ARKANSAS NUCLEAR ONE - UNIT 1

IMPROVED TECHNICAL SPECIFICATIONS SUBMITTAL

03/19/01 Supplement

March 19, 2001

FIGURE ~~3.1.2-1~~ 3.4.3-3 (Page 1 of 1)
RCS INSERVICE HYDROSTATIC TEST H/U & C/D LIMITS TO 31 EFPY

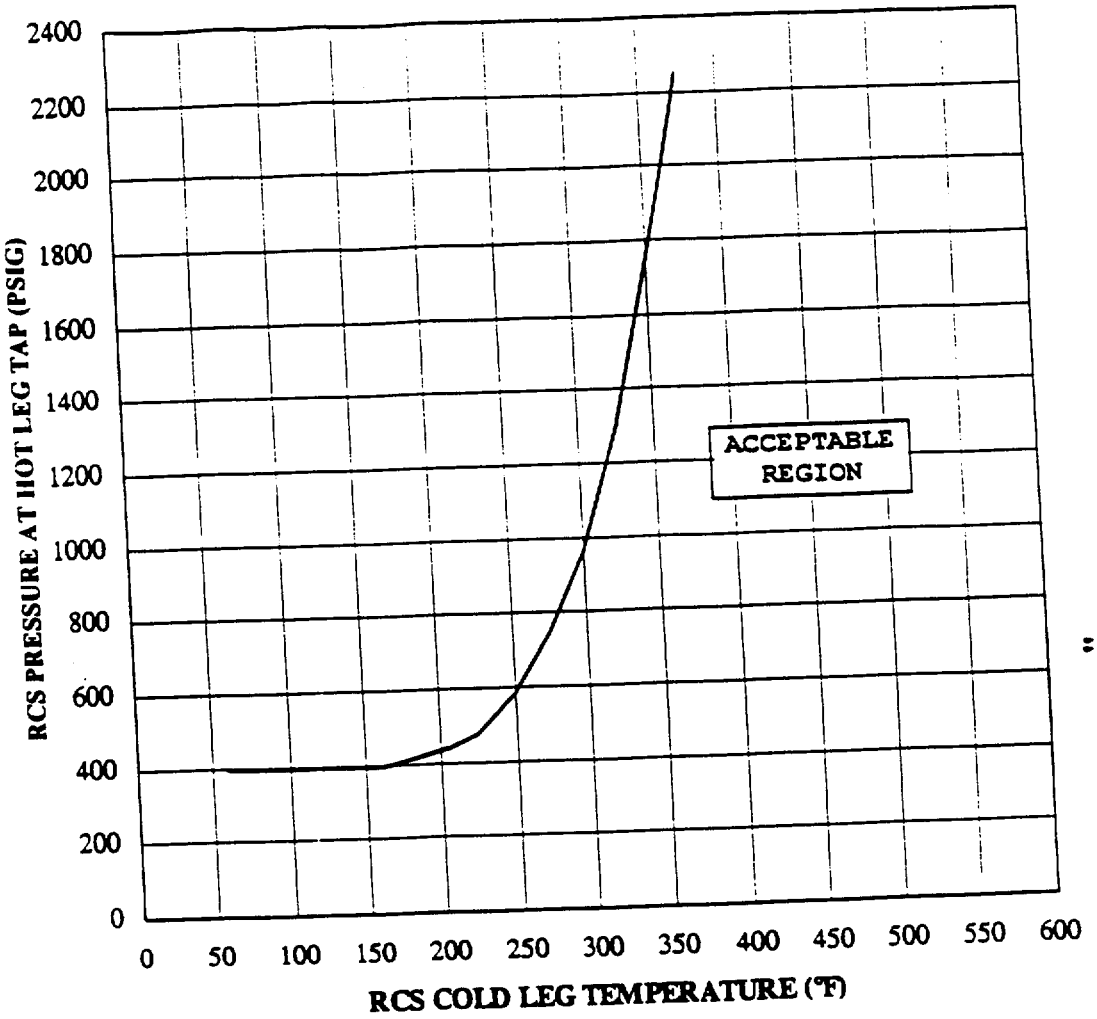
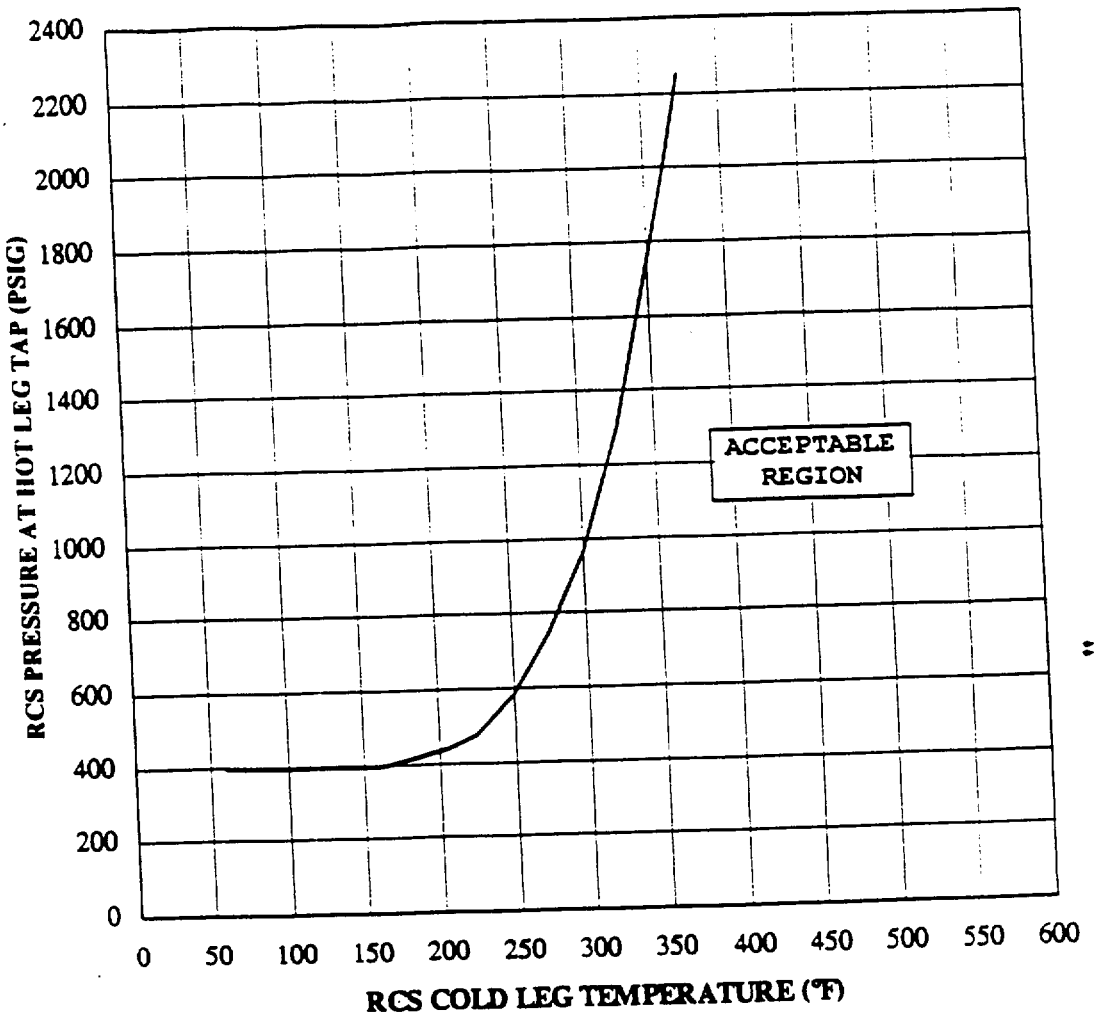
[Reviewer's Note: These inserts are revised versions of CTS Figures 3.1.2-2, 3.1.2-3, and 3.1.2-1. They are, respectively, ITS Figures 3.4.3-1, 3.4.3-2, and 3.4.3-3.]

CTS
Fig. 3.1.2-1

FIGURE ~~3.1.2-2~~

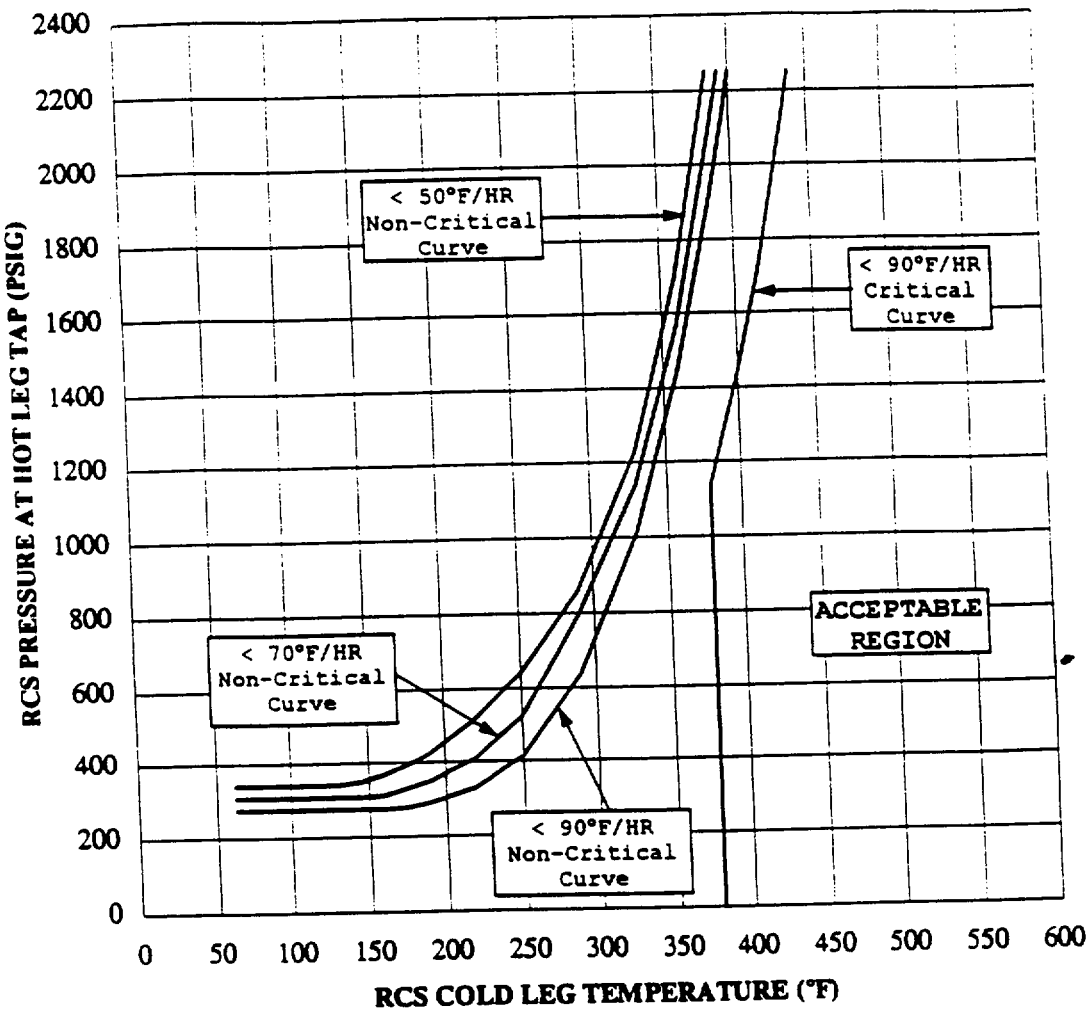
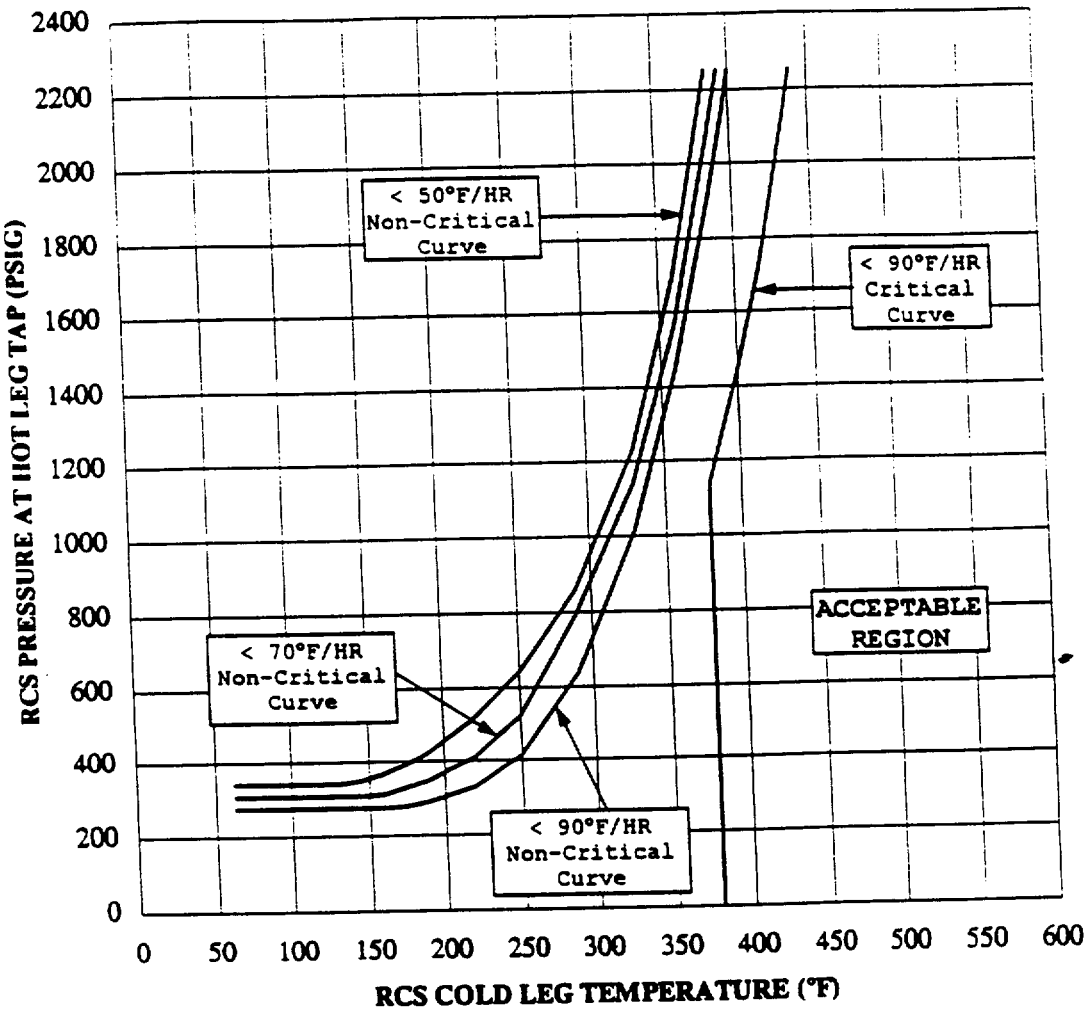
Fig. 3.4.3-1

FIGURE ~~3.1.2-3~~ 3.4.3-2 (page 1 of 1)
RCS COOLDOWN LIMITS TO 31 EFPY

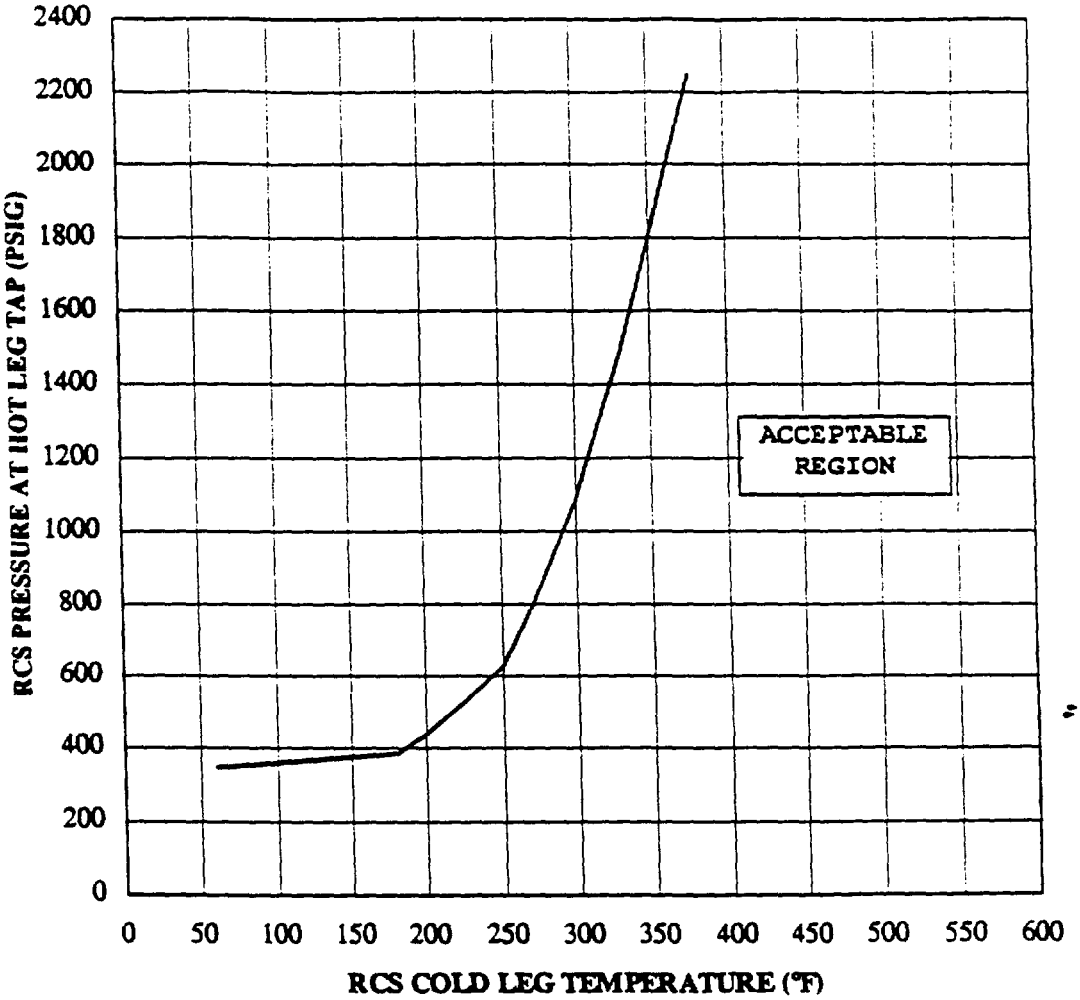
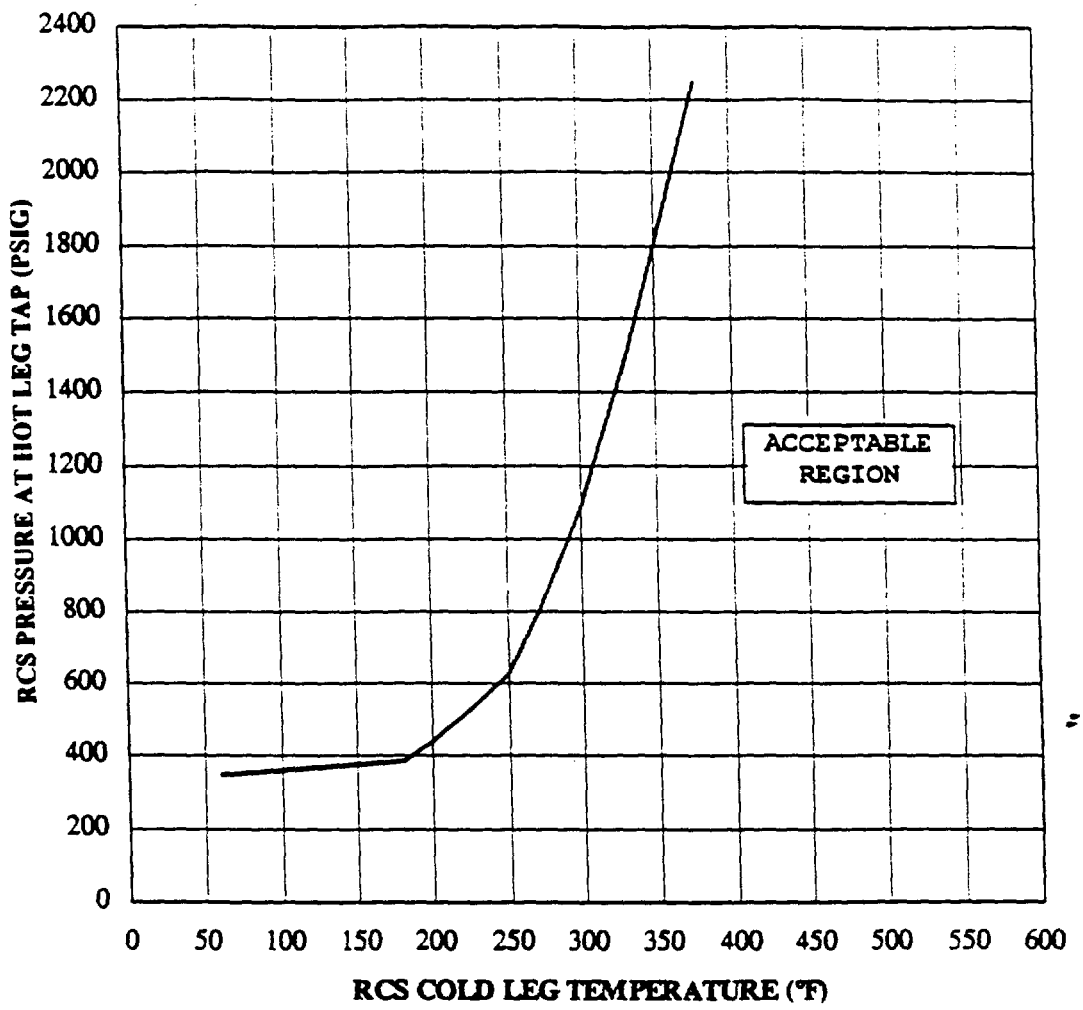
Fig. 3.1.2-3
